Board of Aldermen Request for Action

AGENDA ITEM: Bill No. 3129-26 Clay Creek Meadows Phase 2 and 3 Conceptual Plan Approval – 1st reading by title only.

PLANNED DEVELOPMENT OVERLAY CONCEPTUAL PLAN CLAY CREEK MEADOWS - PHASE 2 & 3 A SUBDIVISION IN PART OF THE SOUTHEAST QUARTER OF SECTION 35, TOWNSHIP 54 NORTH, RANGE 33 WEST SMITHVILLE, CLAY COUNTY, MISSOURI

STAFF REPORT

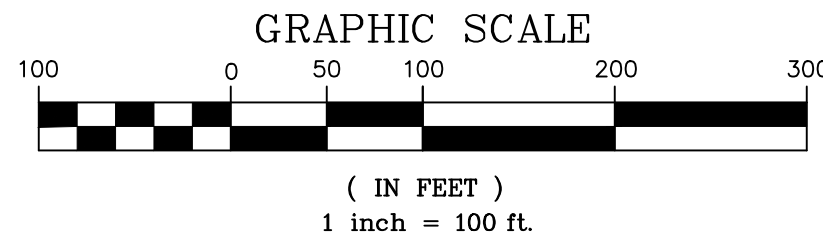
The applicant has submitted a Conceptual Plan request to change the method for calculating lot coverage. The existing ordinances calculate the maximum lot coverage at 30% of EACH LOT. Applicant's sole purpose of its' conceptual plan is to modify the maximum lot coverage to be calculated as an entire subdivision but not changing the 30% maximum coverage requirement. The currently approved site plan for the development includes each of the lots that back up to 169 Highway to have additional square footage per lot to allow a larger buffer from the highway impacts, significantly increase the total square footage of each lot. Additionally, there are two cul de sacs and one knuckle in the road system that significantly increase the square footage of those lots as well. These increased size lots then reduce the overall size of other lots.

The impact of these items makes some cul de sac lots with very low coverage and other lots with higher than allowed coverages. There are 11 lots with an excess coverage (30%+) and 12 lots with a coverage of less than 21% coverage. The proposed conceptual plan change would result in an overall coverage of 24.8%, well below the maximum coverage limit of 30%.

The proposed change does not impact the stormwater design as it was designed based upon 30% coverage and the actual will be 24.8%

Staff recommends APPROVAL of the proposed conceptual plan based upon the intent of the district is still met with 24.8% coverage.
